Business Unit:	Electric	PI00000563
Product range:	Han-Yellock housings and covers	Date: 2026-07-13
Author:	Tarek Spreen	Page 1/1
Title:	PI Han-Yellock low mating force

we want to inform you about a change of the Han-Yellock® profile sealing without effect on the function and application of the product.

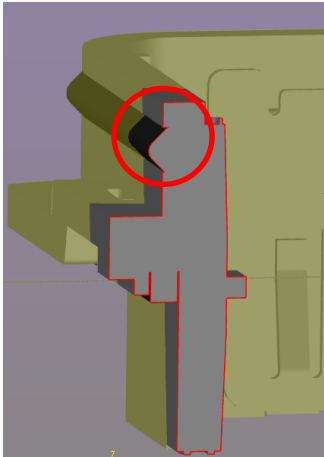
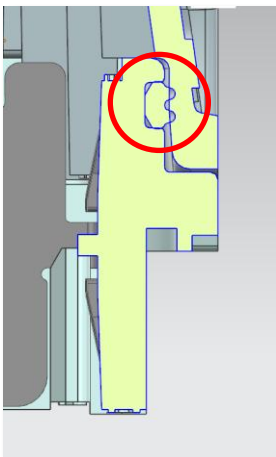
1. Concerned part number:	
111230003* 1112+00121+ 1112+0054++	
2. Description of changes / news:	
Change profile sealing from one lamella to double lamella with lower altitude and thereby reducing the mating force.	
one lamella (old) 	two lamella (new) 
3. Impact on product specification:	
Reduce mating force of hood & housing to ~40N Keep IP65 / IP67 protection level	
4. Scheduled date of implementation:	
2026-10-01 - mixed deliveries of new and old version are possible	
5. Identification of change:	
new revision level (see attached)
